Pre-review of mechanical designs for the MPPC-PCB & LGP module toward mass production

7 December 2020

Tsunayuki Matsubara (KEK)

1) Outer dimension

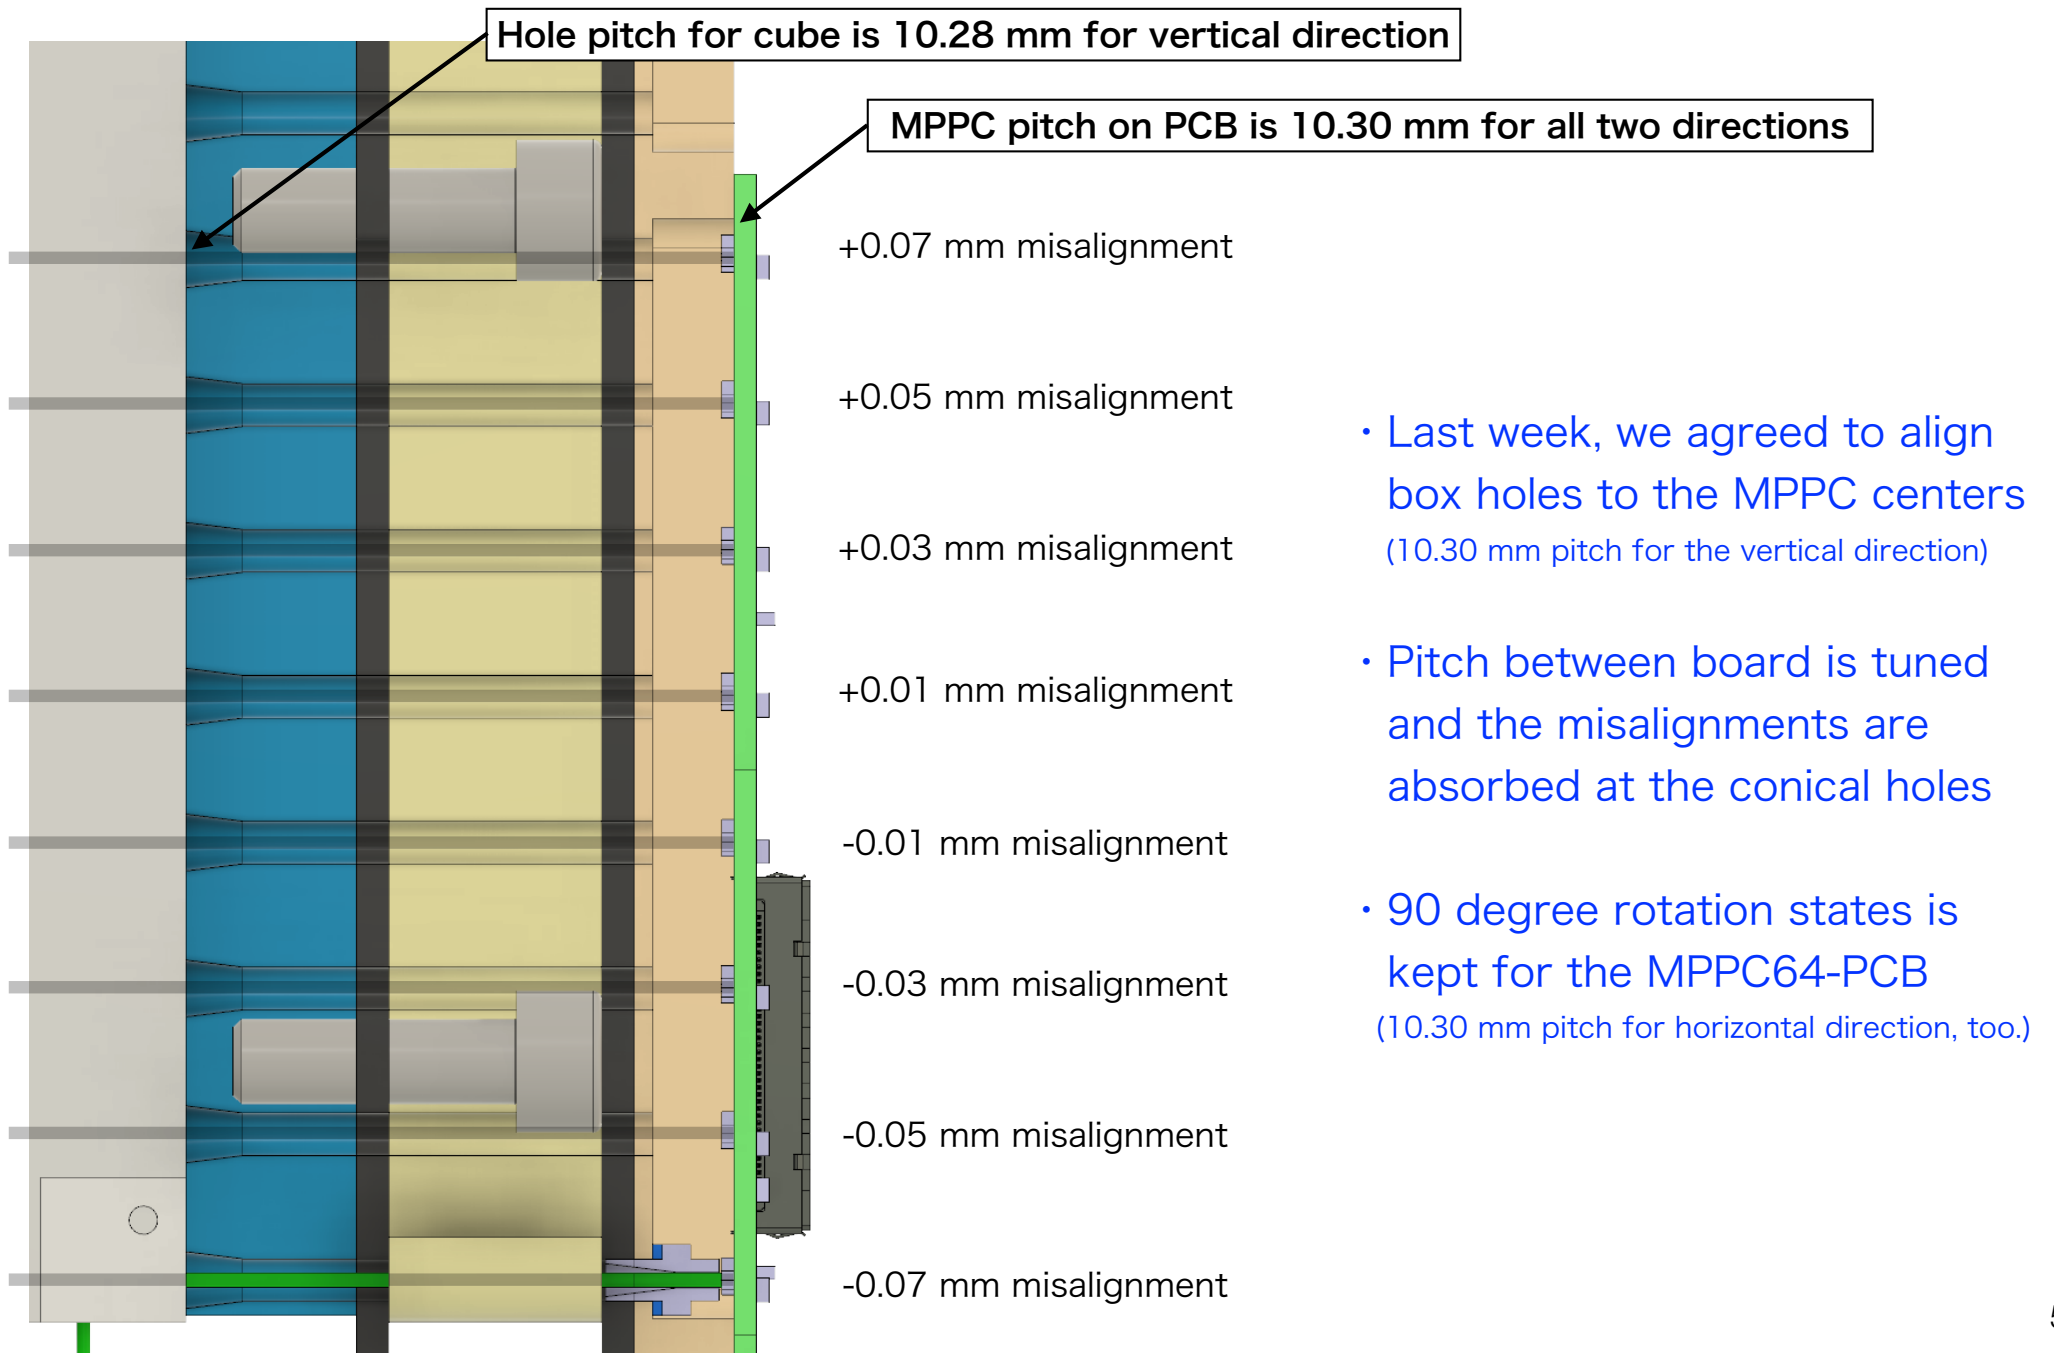
- There is clearance between vertical boards with current design
- We plan to require negative tolerance for the outer dimension

3) Interference with the LGP module

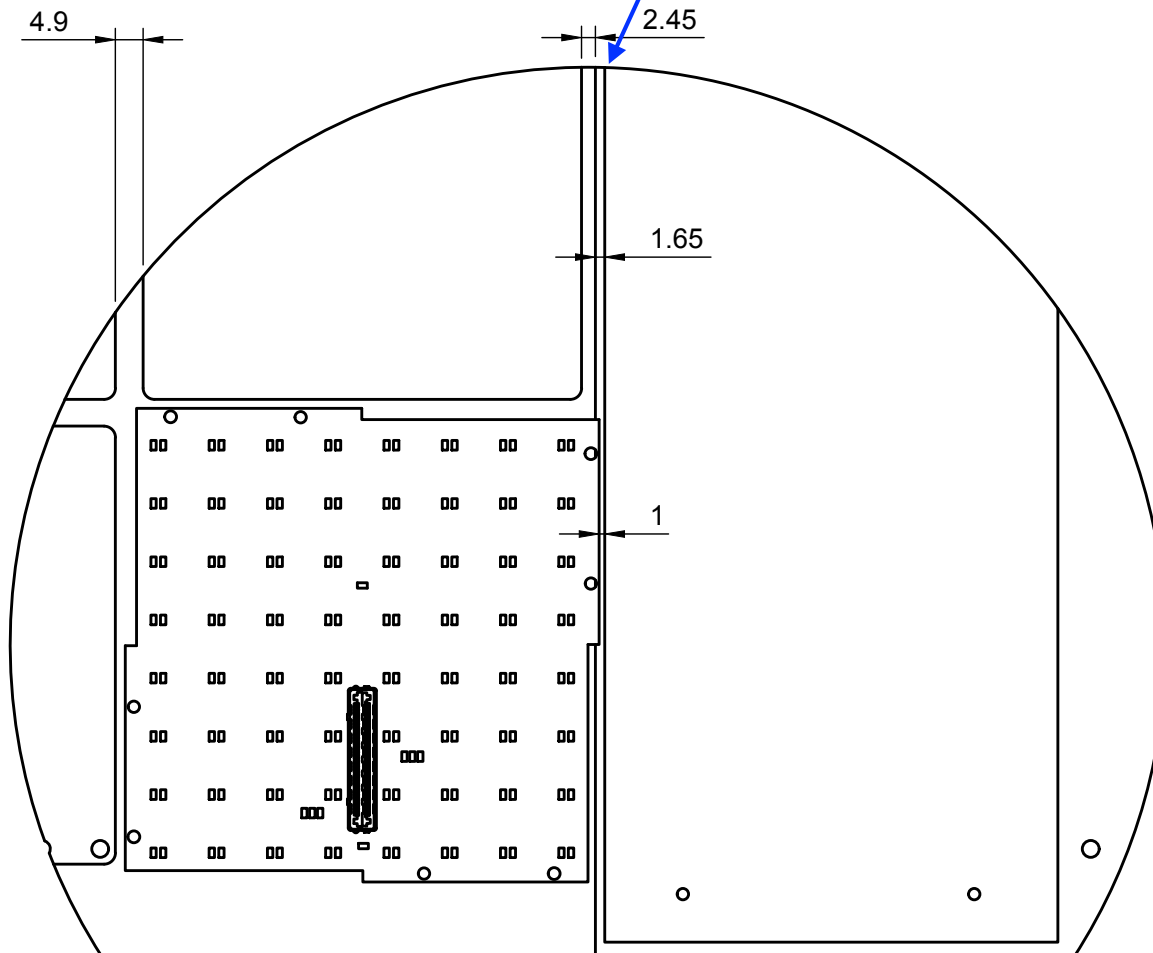
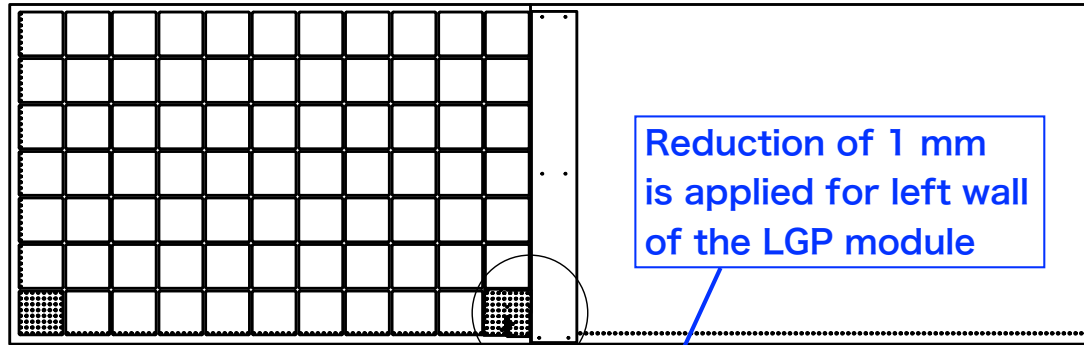
- Larry pointed interference between MPPC-PCB and LGP module for the side wall of the box.
- We agreed to reduce the thickness of the container for the wall LGP module from 2 mm to 1 mm
- This is only for 2 modules located at the boundary of right/left plates. No issue (e.g. strength and manufacturing) is expected for the wall module by reducing the thickness with -1 mm.
- It allows us to enlarge **the thickness of the G10 grid wall** to screw MPPC-PCB. **I proposed 0.65 mm (next page).**
- We can then keep the enough clearance to mount the narrower LGP module.

- $2.45+0.65$ mm would be a reasonable choice for the G10 grid thickness?
- 1 mm clearance is then kept between the G10 wall to the LGP module

4) Alignment pin & screws

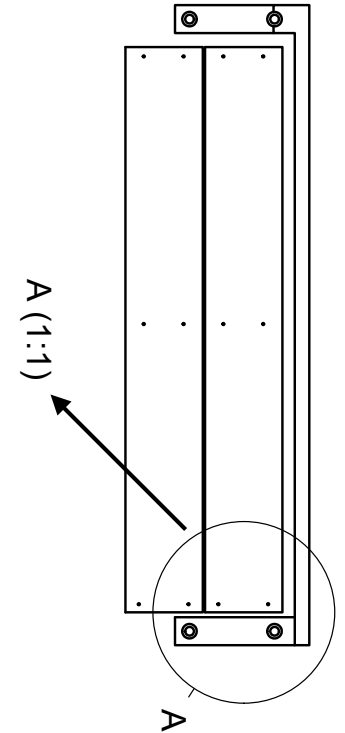
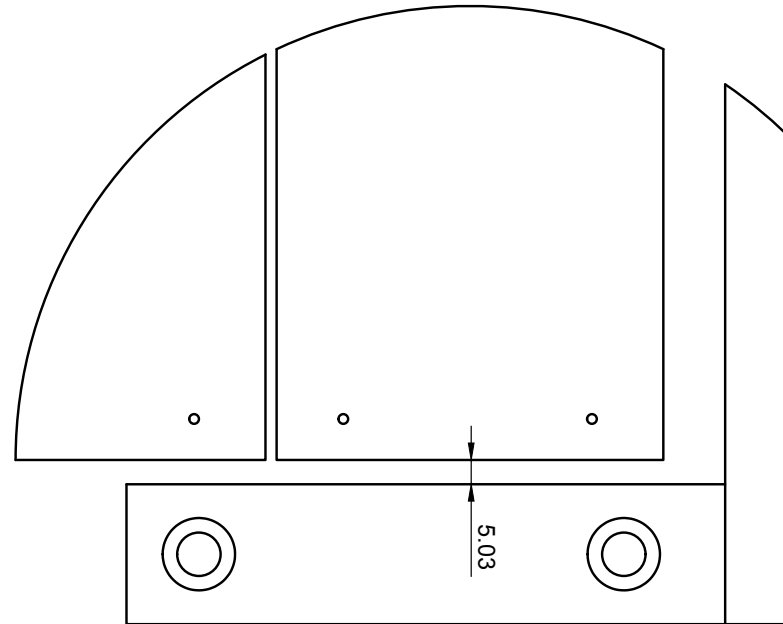
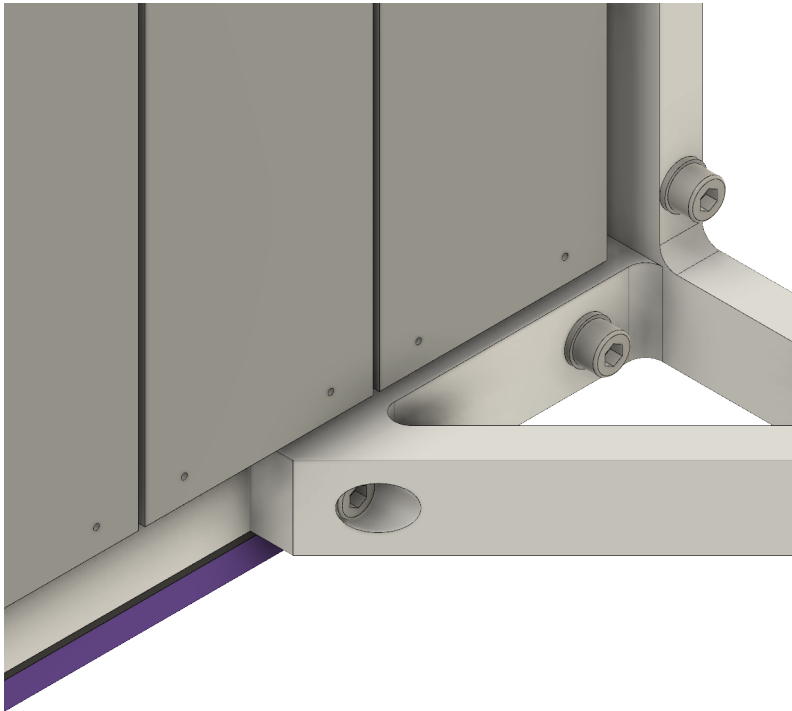
Still to do...too many holes for alignment pins

The four corner holes of the MPPC board are designed for M2 bolts. We do not need to use all of the remaining four holes for alignment pins, only 2.

I need to figure out the pin pattern and propose a slot for the MPPC board that makes sense with tolerances.

We need to know the final design as soon as possible

1) Outer dimension (Interference b/w modules and bracket)

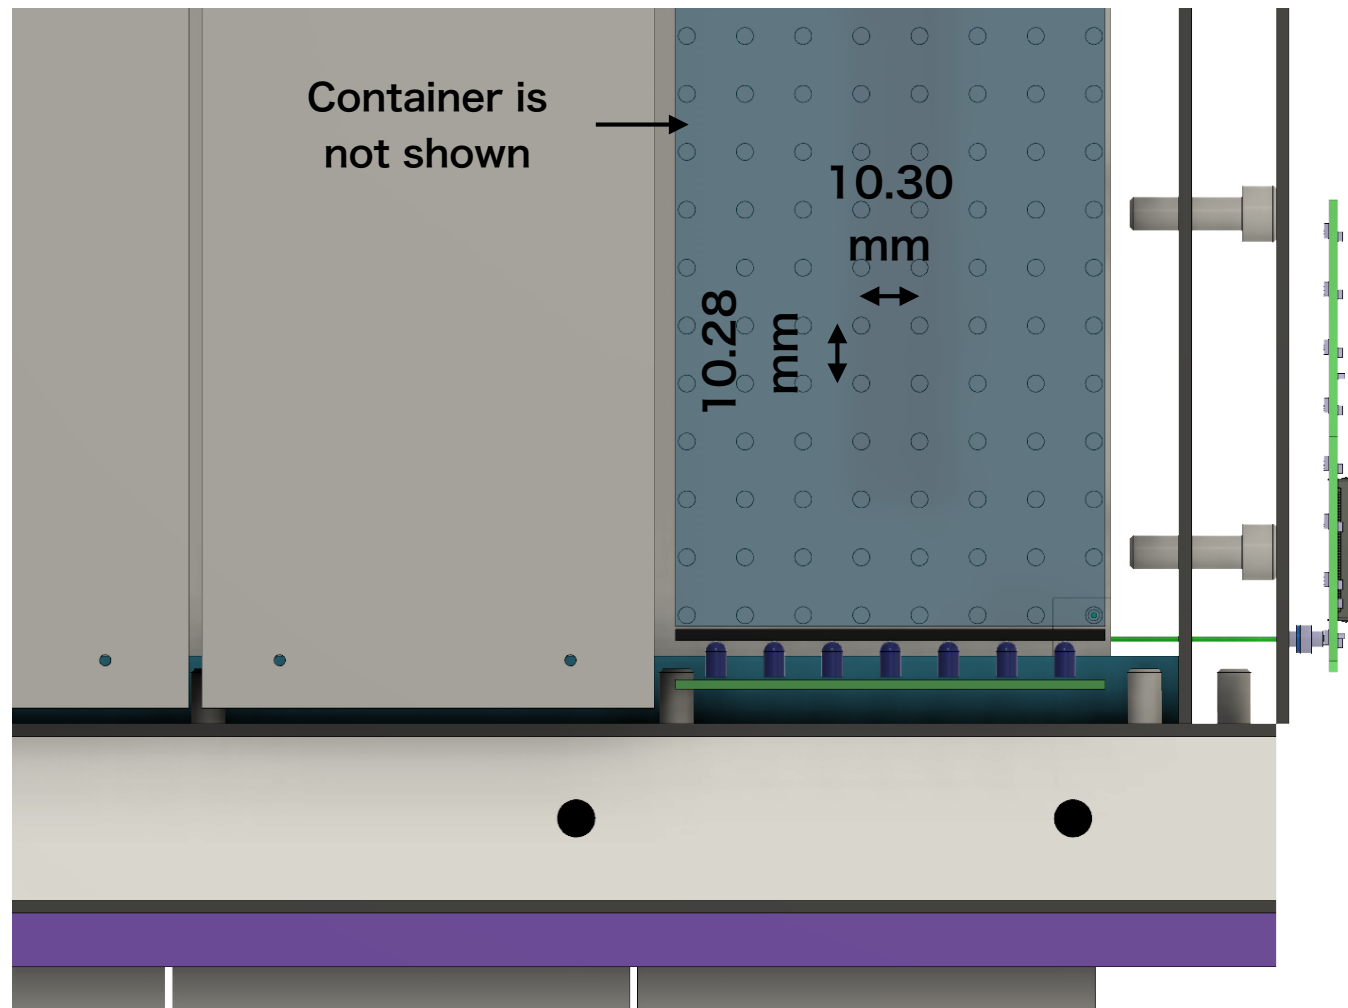
- 2 mm clearance between modules
- No interference with bracket (and other parts for sure)
- Space of ~5 mm at the corner looks safe for routing of cable from LED-PCB in the module. (3 mm is enough at maximum)
 - We would have to attach the cable first before mounting the module but it looks feasible.

3) Cabling

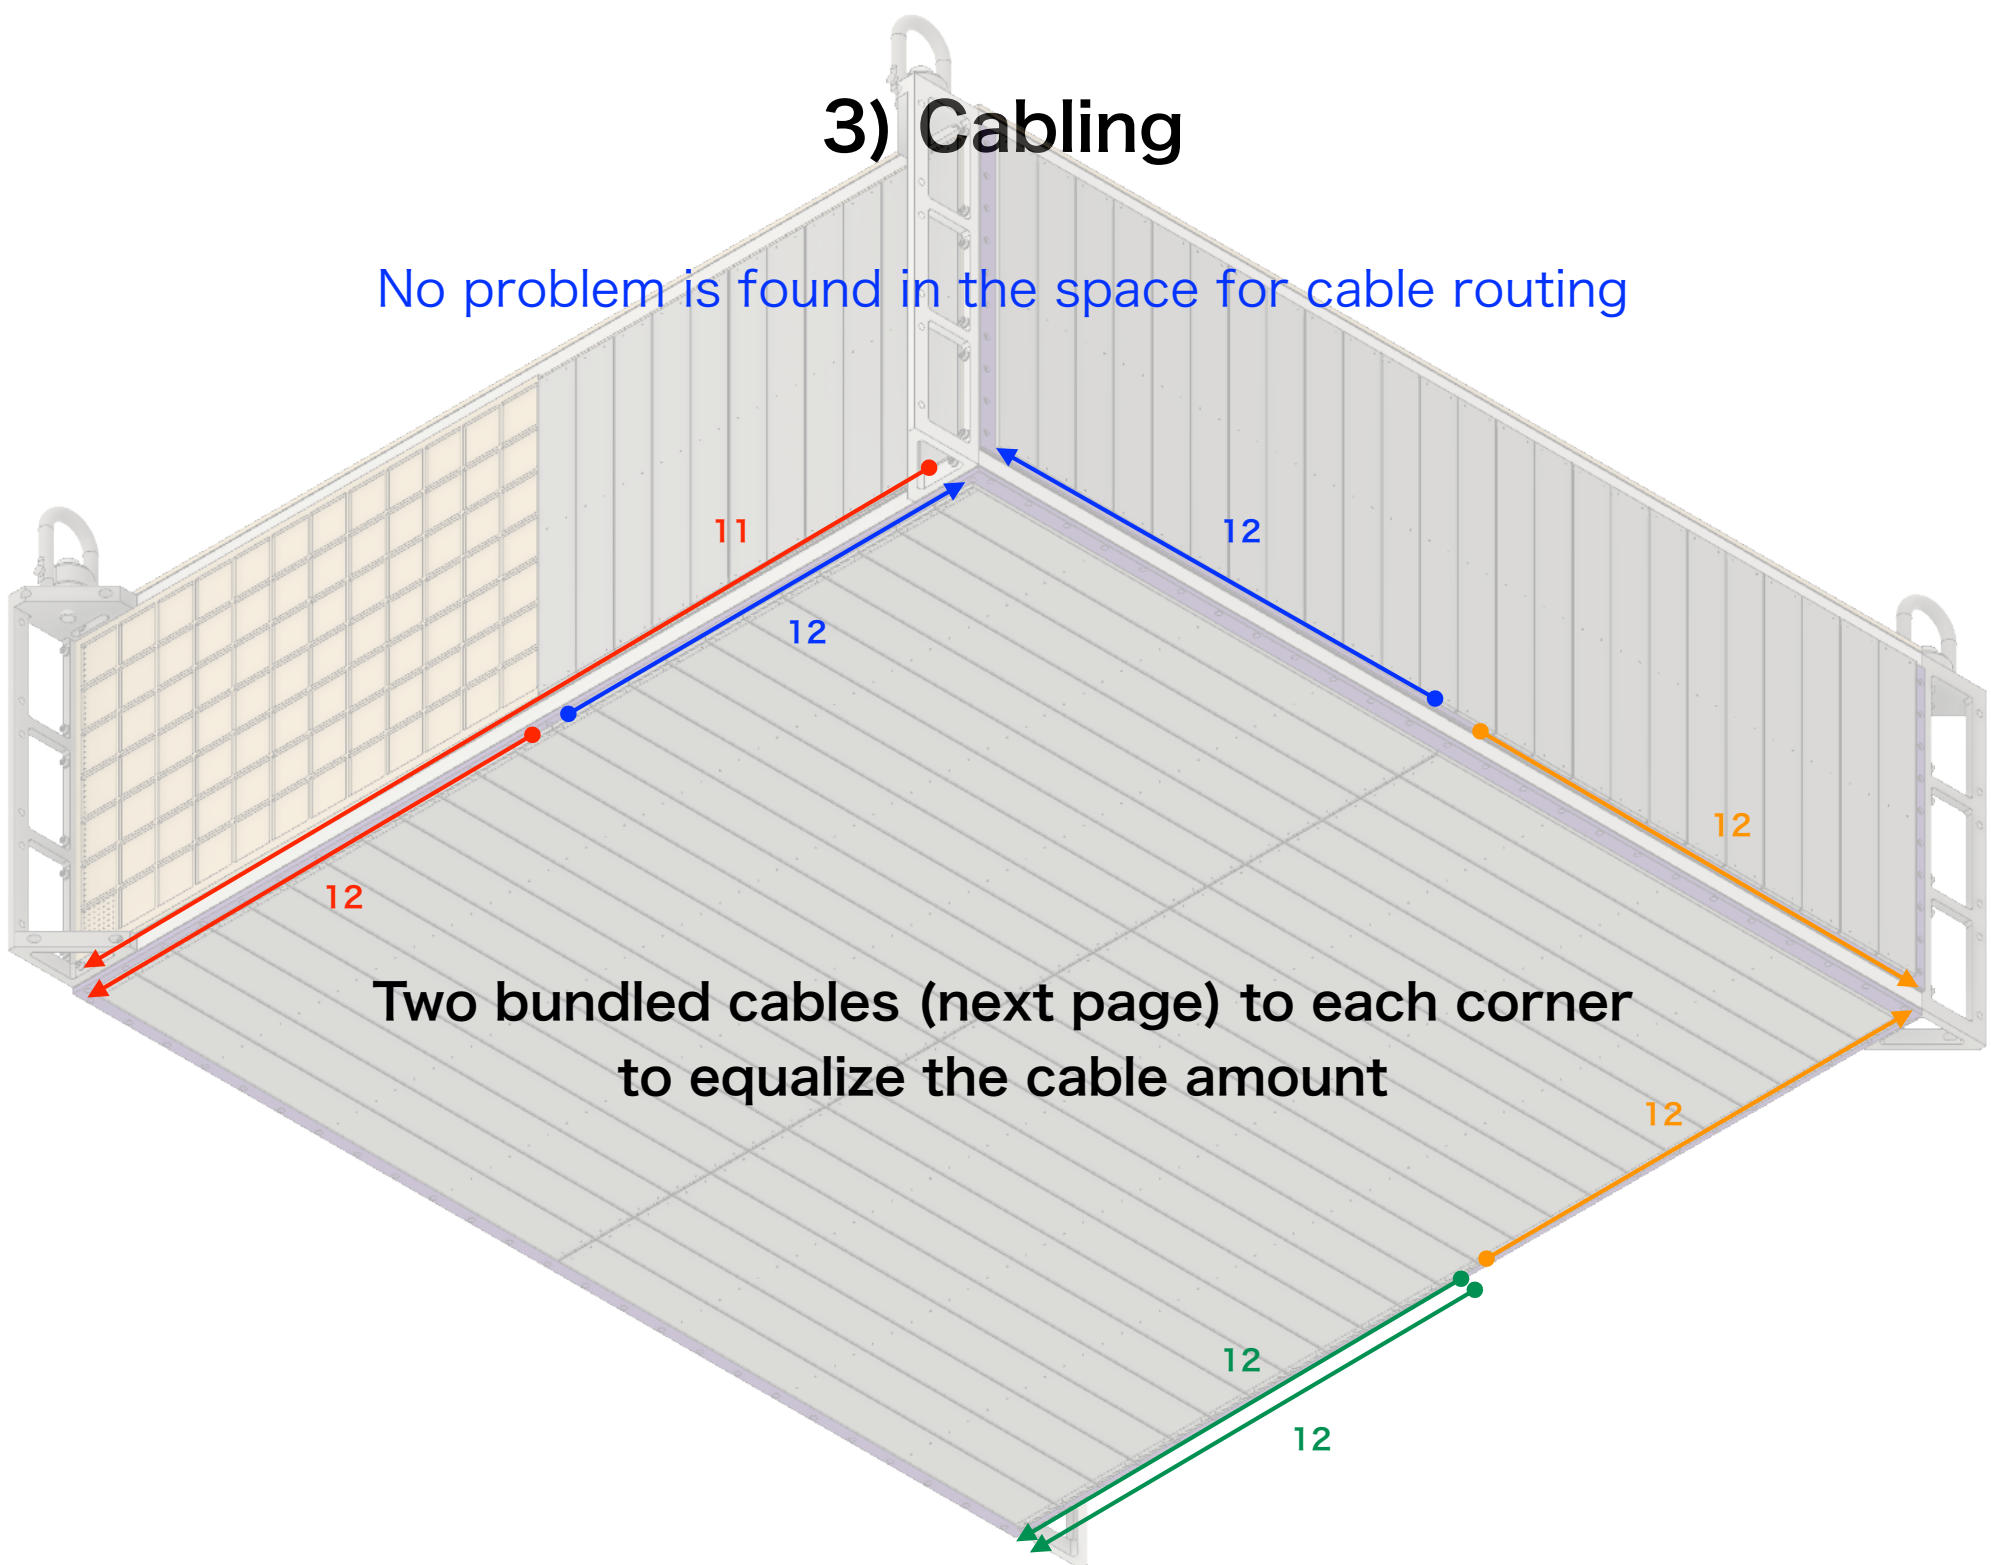
No problem is found in the space for cable routing
